EIS Scoping Comment on Impacts of Vessel Traffic at the Proposed Gateway Pacific Terminal (GPT)

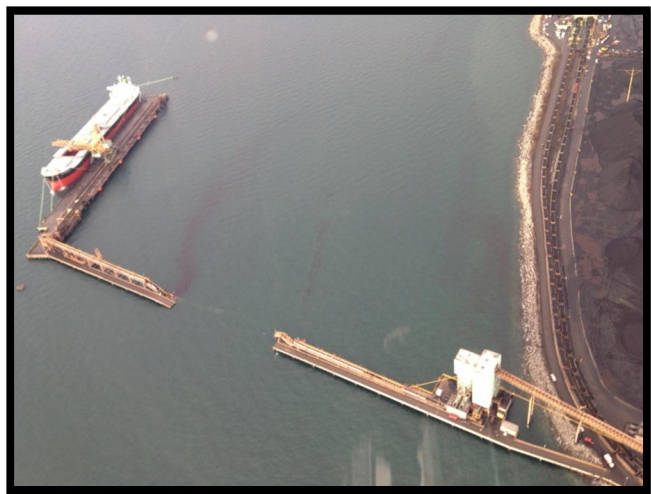
By analyzing aerial photographs and illustrations of GPT's site-specific wharf and trestle plans and comparing those plans to geographic features of the proposed site location available via Bing Maps, aerial view, I was able to determine the proximity of the proposed GPT wharf to the current BP Refinery petroleum shipping and receiving docks. The image above shows the current BP Refinery docks with one oil tanker (shown at left-center) and the proposed location of the GPT wharf (shown at lower center). The proximate distance between the two docks is less than 3,000 feet. For a Capesize bulk-cargo vessel, a distance of 3,000 feet represents a mere three boat lengths!

With the BP Refinery dock and the proposed GPT wharf oriented essentially parallel to the shoreline, both would be subject to similar tidal currents and wind patterns. Oil tankers approaching BP's dock, from Rosario Strait, would pass by in close proximity to the proposed GPT wharf. And Capesize bulk-cargo vessels approaching or departing from the proposed GPT wharf, Berth 1 would maneuver *within three boat lengths* of the BP Refinery dock.

Under the 1999 Settlement Agreement, Pacific International Terminals agreed to conduct a Tidal Current Study (2.10e) and a Vessel Traffic Analysis (2.10a). Combined data from the Tidal Current Study
